GOVERNMENT REVIEW TEAM SEPT, OCT, 2008

RE: Mississauga Bus Rapid Transit

Environmental Assessment Addendum

Re: Response to Draft Environmental Assessment (EA) Addendum

Figure 1: Utility Relocation Plan and intersection layout—Winston Churchill Boulevard

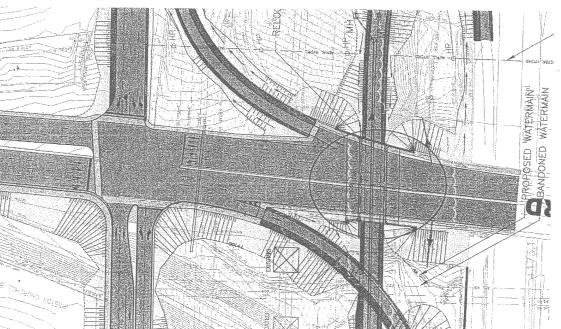
14. Is it possible to obtain a copy of the	Attached as Figure 1.
revised drawing at the Winston Churchill	
and E-N/S ramp terminal intersection?	Off III
15. With regards to the additional lane for	Documentation appended, drawn from the Off-Highway
Winston Churchill NB, it states that this	Transit-Supportive Improvements study (2005), the Park &
additional lane was reviewed by MTO. I	Ride Lots Preliminary Design study (2007), and the
was not aware that this had been	Mississauga BRT West Preliminary Design report (2008).
previously reviewed by the ministry.	The proposed plan showing the intersection arrangement
Can you please provide me with the	was reviewed by the Transit-Supportive Improvements
documentation that warrants the	Study project team and presented to MTO Central Region
additional lane for Winston Churchill	Senior Management on May 29, 2006, July 9, 2007 and
and the removal of the existing	again on August 20, 2007. The requirement for the third

Figure 3a: Detour Plan at Highway 403 Exit ramp to Eastgate Parkway – Two Stage Alternative

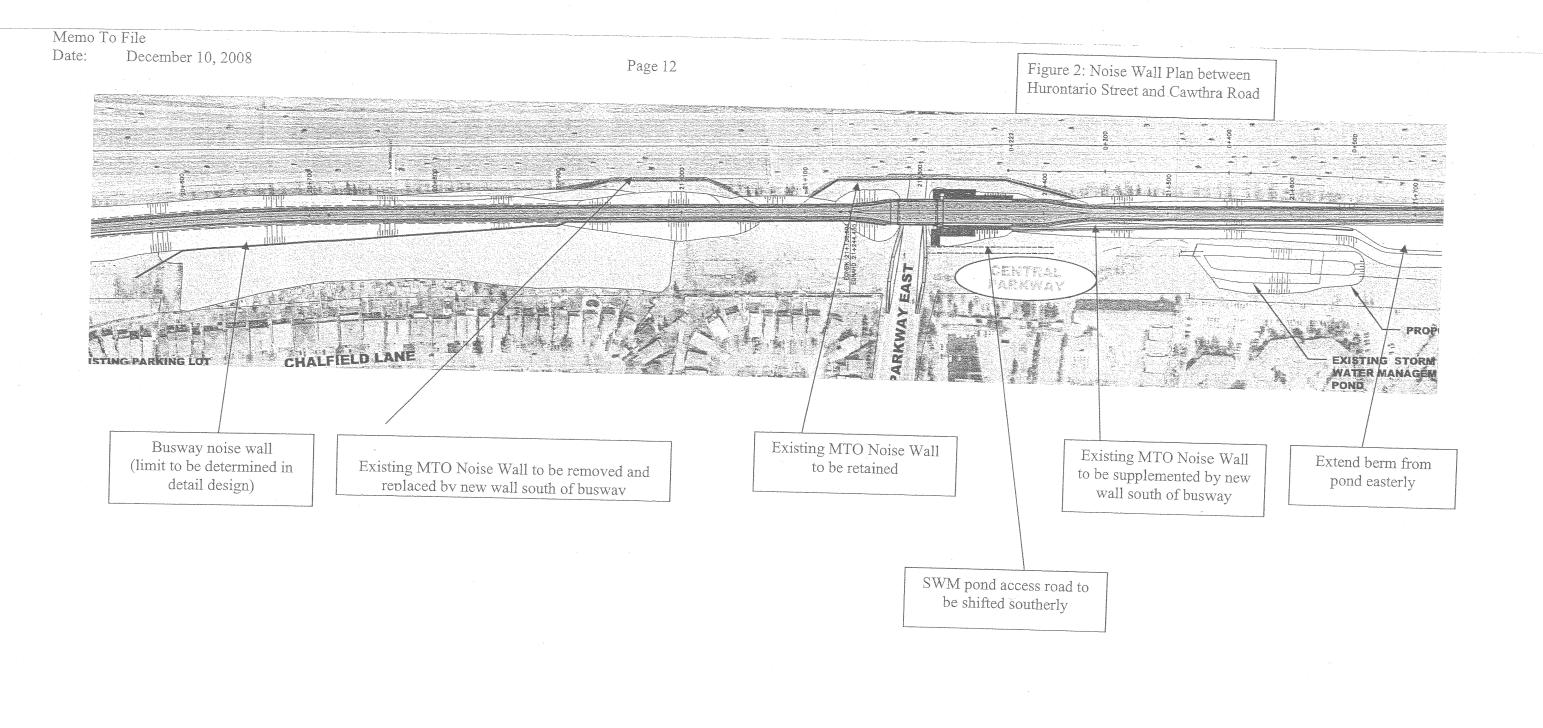
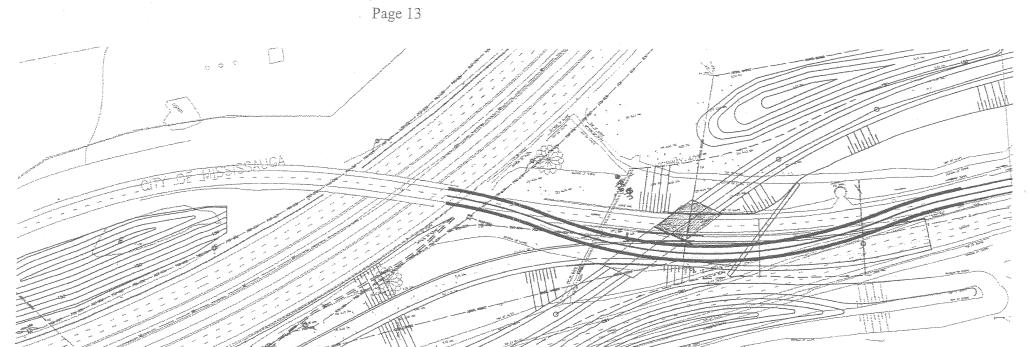
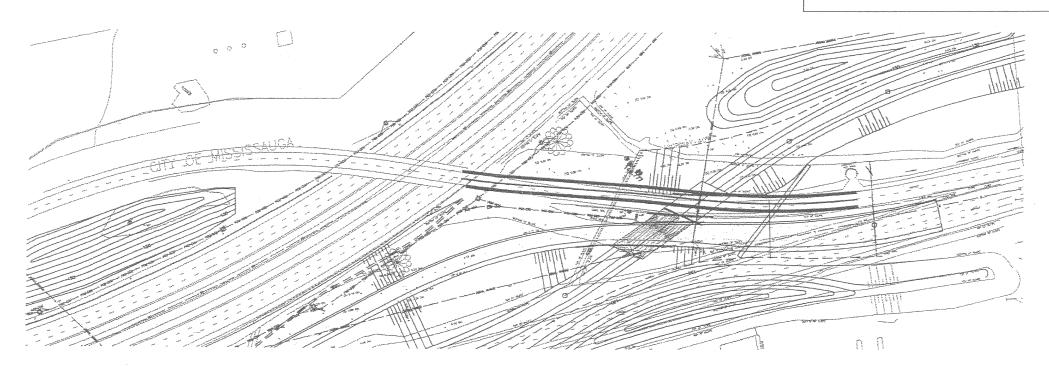
10. Provide staging drawings for the Ramp	Staging drawings are included in current draft of BRT East
realignment and structure construction.	PDR (Nov-08). See Figure 3.

Figure 4a: draft PHM 125 for Winston Churchill Boulevard / 403 E/N/S Ramp Intersection

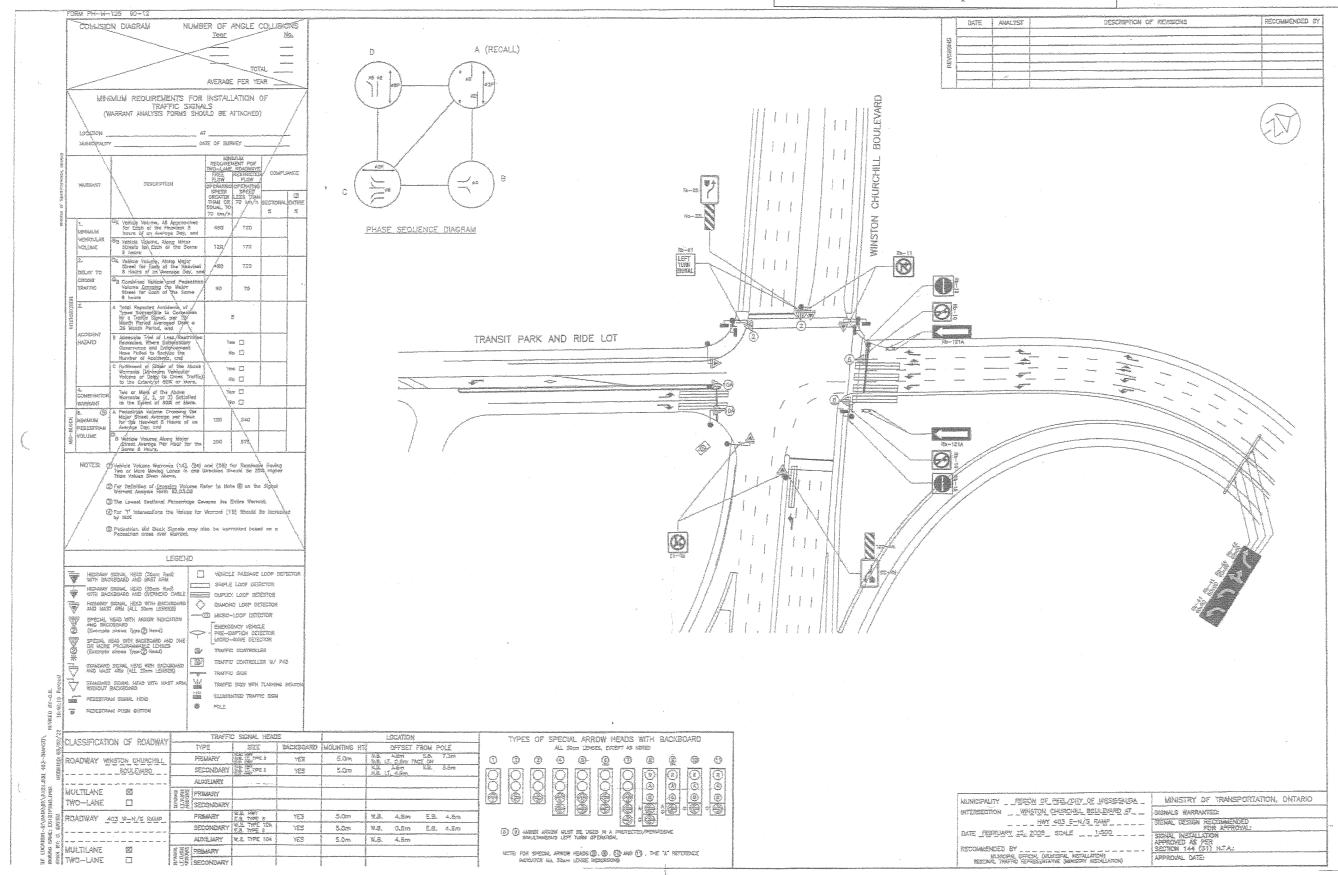
16. Have there been any preliminary drawings for the PHM 125 for Winston Churchill and Erin Mills?	General Comments for the BRT to this so that it can be included in my file?
The draft PHM 125 drawings were included in Appendix D of the draft Preliminary Design Report for the Park & Ride Lots, submitted to MTO for review in August 2008. They are attached as Figures 4a and 4b. The drawings will need to be modified to reflect the changes in item 9 above.	Response Part of the problem in documentation may stem from the turnover of Ministry staff on this particular project; it may be that additional documentation may be found in the files of the previous Project Managers Nancy Adriano, Ayvun Jeganathan, Ansar Ahmed, Jason White, and/or Has Shah.
